Staff Memo

To: Salt Lake City Historic Landmark Commission

Re: PLNHLC2018-00219 New Construction

CONSTRUCTION OF THREE NEW SINGLE FAMILY ATTACHED DWELLINGS

CONCEPT RENDERING - FROM VINE ST.

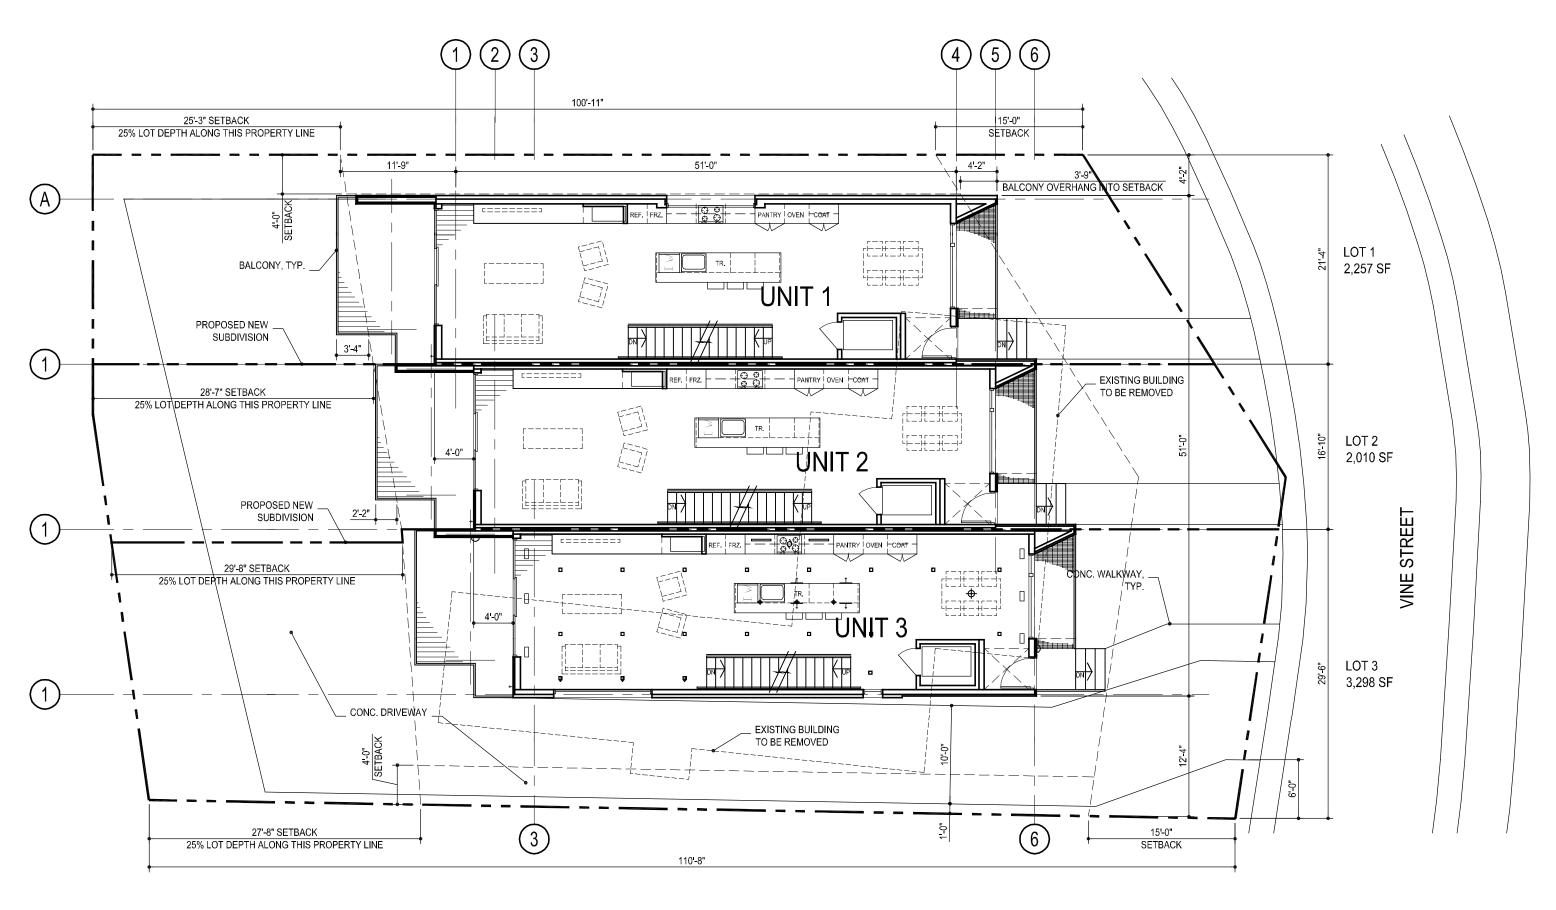
Addressing discussion points raised at the Commission meeting on June 7, revisions to the porch design provide outdoor seating and interactive social space, introduced by semi-public/private landscaped front yard.

- The shading device was converted into a front porch
- This achieves the goal of creating a semi-private space that can function as a social interface with the street
- Helps establish a pedestrian friendly quality that encourages walking and social engagement.
- Site plan had already moved the cars to the rear eliminating the use of a backyard, the porch will continue the idea of bringing the activity to the front and connecting the project to the street.

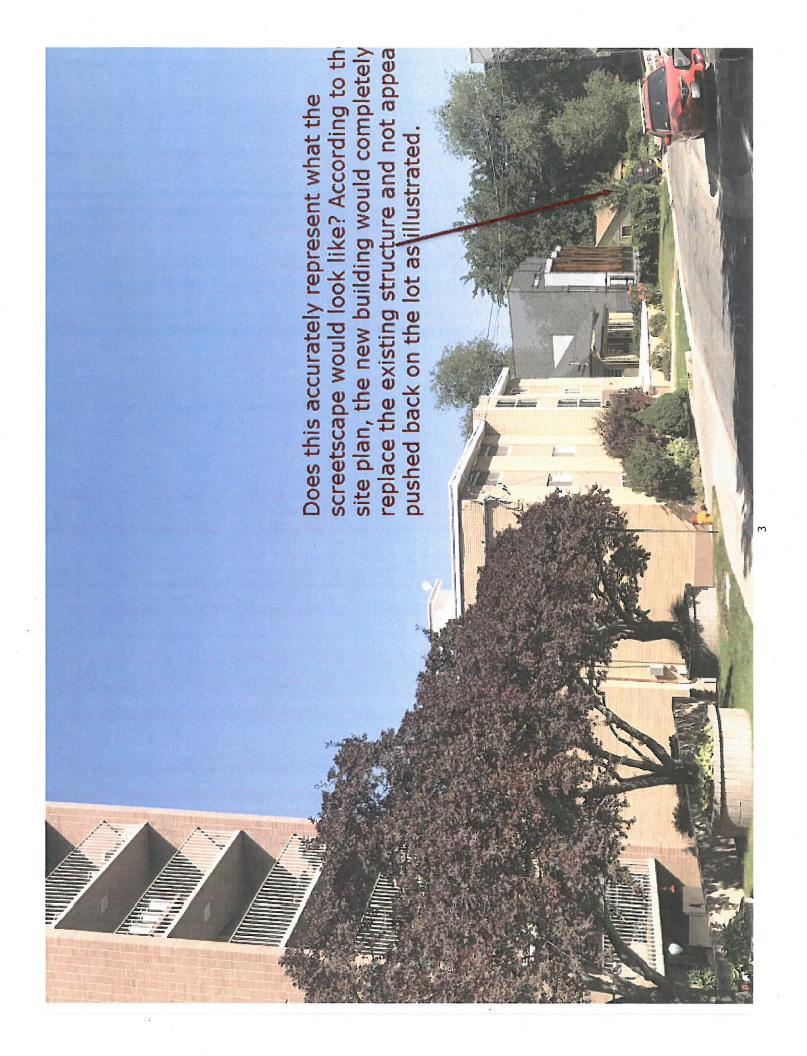
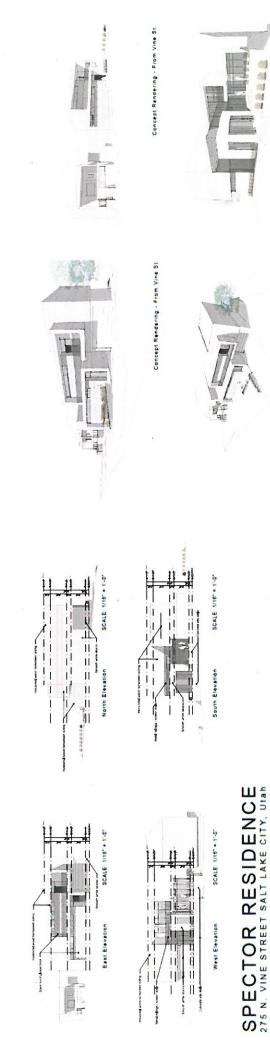
I downloaded and went through the staff memo for the upcoming meeting this week and have a few questions for you about it.

- In the North to South view image included below, the provided image shows the proposed driveway in the center of the lot, not at the South end where it would be. In addition, the new structure would not face the angle that has been presented, it would face the dumpster and car across the street. If the image were to scale and positioned correctly, how much of our home would be visible from this position on the

- In the South to North view image included below, the new structure appears to be situated further back on the lot that it would be. You can still clearly see the current home in the image which, according to site plan, would be completely replaced by the new building.
